WDG File: 008-20

Project: 1842 King Street East
File No: **ZAC-21-021**
Comment Response#: 1

Document(s): Tree Protection Plan (April 2021)
Landscape Plan (April 2021)
Urban Design Brief (April 2021)

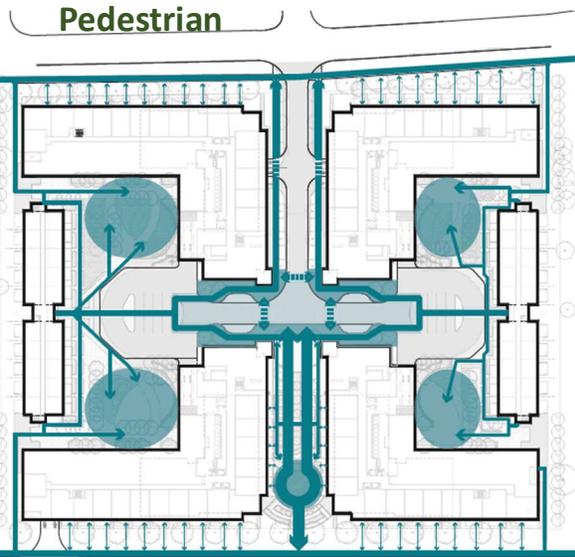
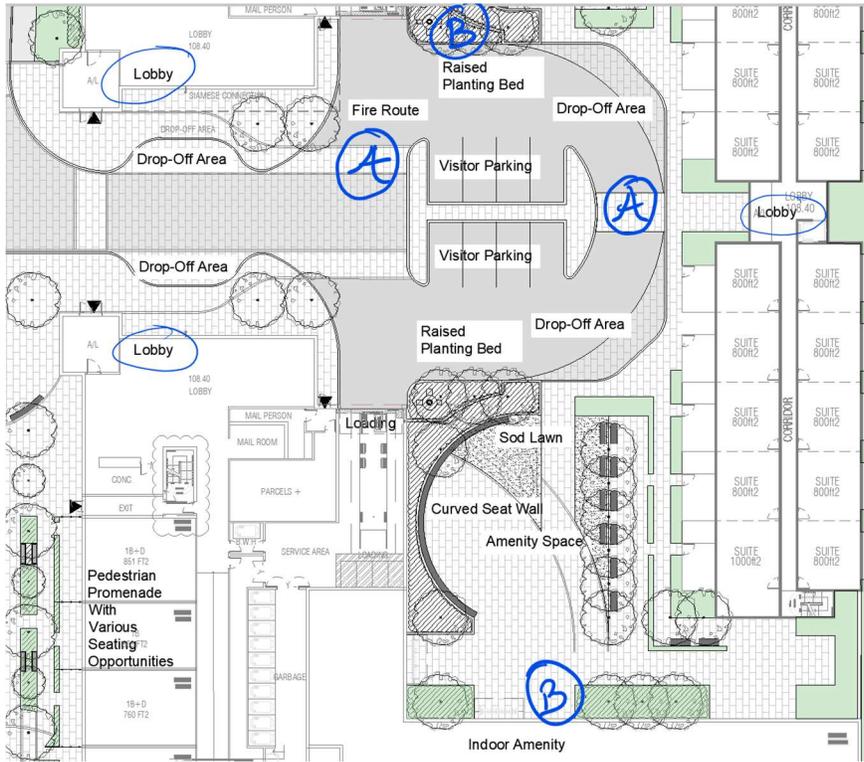
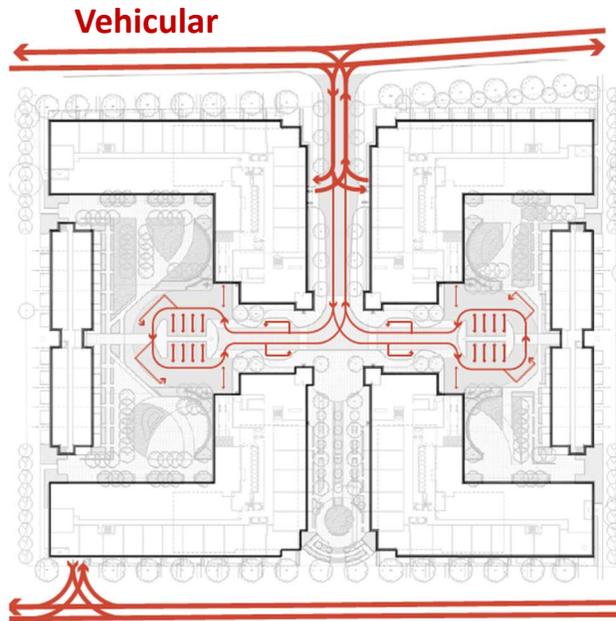
Comment: Streetscapes- The internal road providing access to the new development should have sufficient clearance to provide a minimum 3m wide landscape buffer between apartment units at grade and the public sidewalk. Possibly deeper setbacks can be provided where the road widens; the internal sidewalk may be better placed at the curb to allow for a larger contiguous landscape area along the building perimeter, capable to function as a buffer for apartment units as well as a tree planted boulevard for the street.

The internal sidewalk has been revised and placed at the curb to accommodate the above comment.
